Access Compliance Report

Public Rights-of-Way

(Curb Ramps)

Intersection ID: 32165	Main Street: FOLIO CLUB DR	Cross Street: MARIE ROGET WY	Location: NW
ADA ID: 734EF5BFB233	Ramp Type: BlendTrans1	Initial Pass/Fail: Fail	Overall Compliance: No
		Severity Score: 12.5

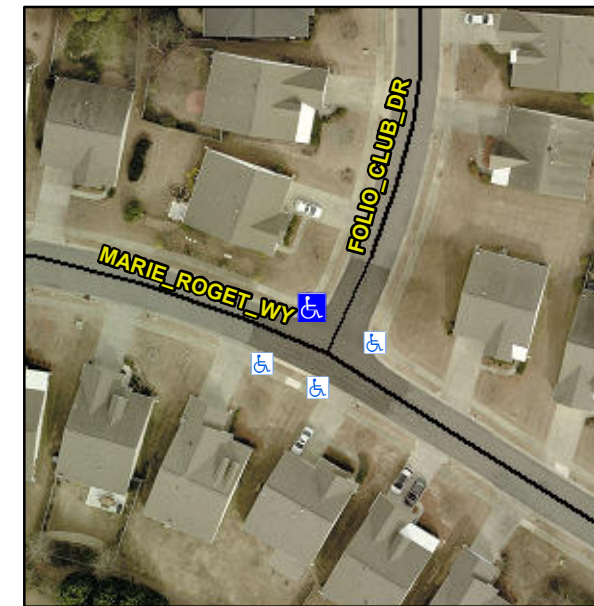
CURB GAP 2.0

Not Found, R304.5.3

Compliance	Description	Data	Compliance	Description	Data
N/A	Ramp Length (in)	47.0	Yes	BlendTrans Slope (%)	2.5
Yes	Ramp Width (in)	66.0	No	BlendTrans XSlope (%)	5.3
N/A	Flare Type LT	N/A	N/A	Flare Type RT	N/A
N/A	Flare Slope LT (%)	N/A	N/A	Flare Slope RT (%)	N/A
N/A	Flare Traversable LT?	N/A	N/A	Flare Traversable RT?	N/A
N/A	Landing Length (in)	N/A	N/A	DWS Provided?	N/A
N/A	Landing Width (in)	N/A	N/A	DWS Contrast?	N/A
N/A	Landing Slope (%)	N/A	N/A	DWS Length (in)	N/A
N/A	Landing X Slope (%)	N/A	N/A	DWS Full Width?	N/A
N/A	Landing Curb? (Y/N)	N/A	N/A	DWS Offset (in)	N/A
N/A	Shared Landing?	N/A			
N/A	Gutter Ponding?	N/A	N/A	Gutter Slope (%)	N/A
N/A	Gutter Lip Ht (in)	N/A	N/A	Gutter X Slope (%)	N/A
N/A	Painted X Walk1?	No	N/A	Painted X Walk2?	No
	X Walk 1 Direction	To SW		X Walk 2 Direction	To SE
	X Walk 1 Width (in)	N/A		X Walk 2 Width (in)	N/A
	X Walk 1 Slope (%)	1.5		X Walk 2 Slope (%)	0.4
	X Walk 1 X Slope (%)	2.8		X Walk 2 X Slope (%)	2.2

N/A	Ramp inside XWalk1?	N/A	N/A	Ramp inside XWalk2?	N/A
	Road Slope (%)	3.4		Clear Space?	N/A
	Road X Slope (%)	2.9	N/A	Clear Space to XWalk (in)	N/A
N/A	Any Obstructions?	N/A	N/A	Storm Grate/Utility Hazard?	N/A
	Obstruction Type			Storm Grate/Utility Type	
		N/A			N/A
			Yes	Surface Condition? (G/P)	Good
			No	Curb Slope (%)	20.0

Remove & Replace Curb Ramp With Two New Directional Ramps or Equivalent.
